WEST HAVEN PLANNING COMMISSION AGENDA

August 27, 2025 6:00 P.M.
City Council Chambers
4150 South 3900 West, West Haven, UT 84401

FINAL SUBDIVISION PLAT APPROVAL

SITE PLAN APPROVAL

Image 1: Site Aerial

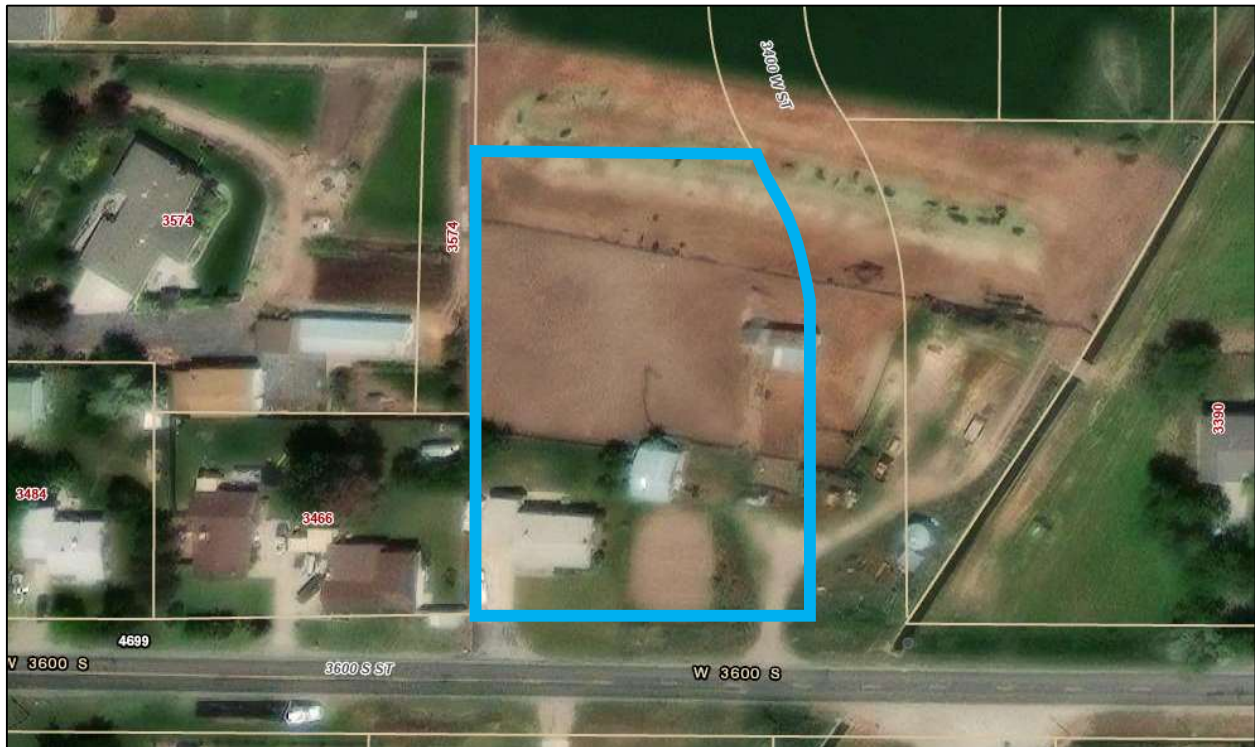
Previously, staff recommended that the commission deny the subject request based on the anticipated detrimental effects of the proposed land use that staff estimated could not be sufficiently mitigated through the imposition of reasonable conditions. The subject request did come before the Planning Commission for review on July 9, 2025, and was then tabled to allow the applicant time to revise the site plan to lessen the anticipated detrimental effects of the use on the surrounding properties. See Image 2 or the attached site plan document for more on the updated site plan proposal.

Finding: The applicant has revised the site plan to lessen the anticipated detrimental effects of the proposed land use and the associated development. The proposed building's size was reduced from 12,000 square feet to 9,750 square feet. This adjustment does bring the proposed building into compliance with the maximum lot coverage restriction for accessory buildings in the rear yard of a single-family dwelling. §157.601 of the Zoning Ordinance restricts the development of the rear yard area to 25% of the total rear yard. The adjusted proposal does comply with these regulations.

However, one condition required by code for the approval of a home occupation is that "the portion of the home occupation shall remain secondary to the residential use" (157.882(B)). Even with the amended site plan, the residential use of the property is still eclipsed by the commercial use of the property in both size and intensity. Despite the proposed building being within the size allowances of the code, the building is much larger than the home (approximately 1,900 ft²) and is likely to generate more traffic. As it is currently exists, staff sees the proposal as a commercial development proposed for a residential lot in a residential

Finding: Although the updated site plan might sufficiently mitigate the nuisance of glare and drastically decrease the potential for noise nuisance, staff finds that all potential nuisances that might occur with the proposed land use cannot sufficiently be anticipated or mitigated through reasonable conditions because of the nature, size, and scope of the business.

Based on the findings listed in Section II of this report, the staff recommends that the Planning Commission **deny** the requested Conditional Use Permit because there are detrimental effects of the proposed land-use that cannot be sufficiently mitigated through the application of reasonable conditions.

1. That the portion of the home occupation, as proposed, would not be able to remain secondary to the residential use.
2. The proposed site plan does not comply with the purpose and intent of the Home Occupation ordinance in “maintaining the peace, quiet, and domestic tranquility within all residential or agricultural areas of the city”.

BLDG 2 - EAST

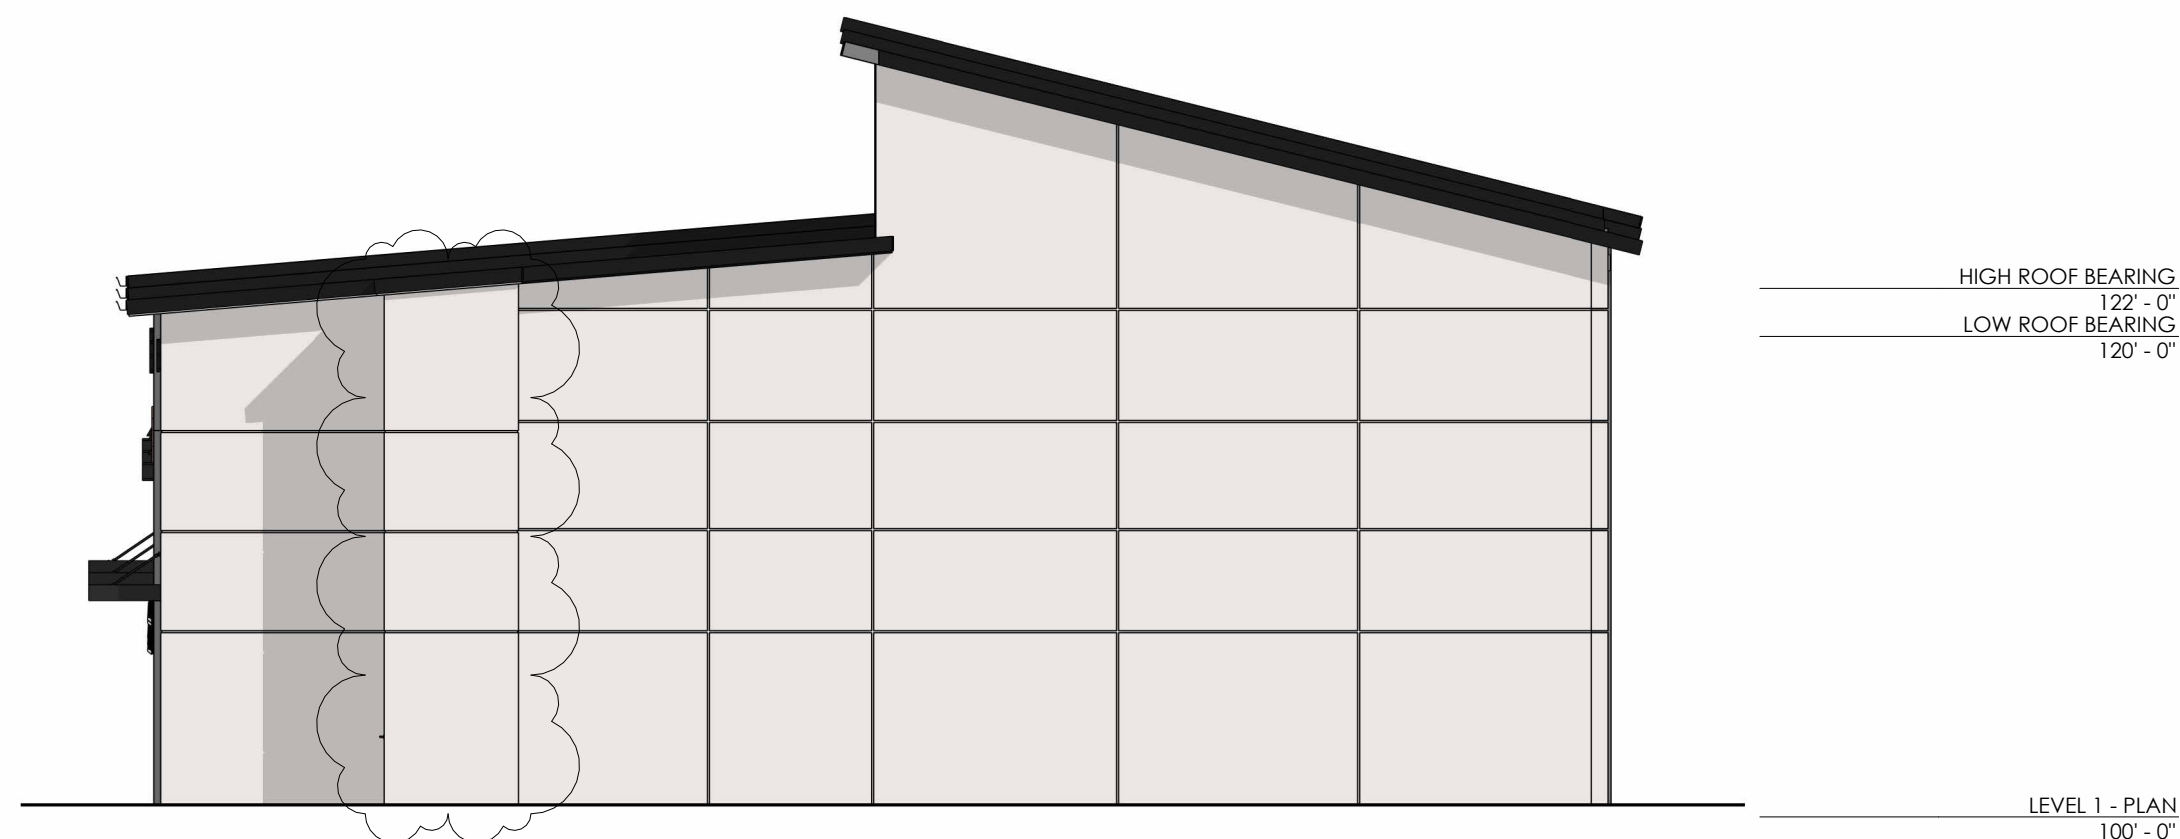
During our initial review of the façade, staff overlooked that the east side of building two also requires 60% of primary materials, because it is within 400' of a major corridor center line, 3500 W. This was missed because the building itself is about 350' from the center line of the road, and there will be an undeveloped lot between this building and the road. However, after performing a last review, the staff found the error. We have informed the applicant, but there has not been sufficient time for them to address the issue. As such, staff recommends the Planning Commission consider the following condition of approval:

“The Planning Commission grants site plan approval for Holiday Landing, a C-2 20-unit flex space, located at 3525 W 4000 S, Parcel 08-050-01, conditioned that spaces in front of the garage doors for building one be designated as employee parking or have a time limit placed and for building two, the east side will need to have 60% primary materials, since it is within 400' of 3500 W and can be seen from that roadway.”
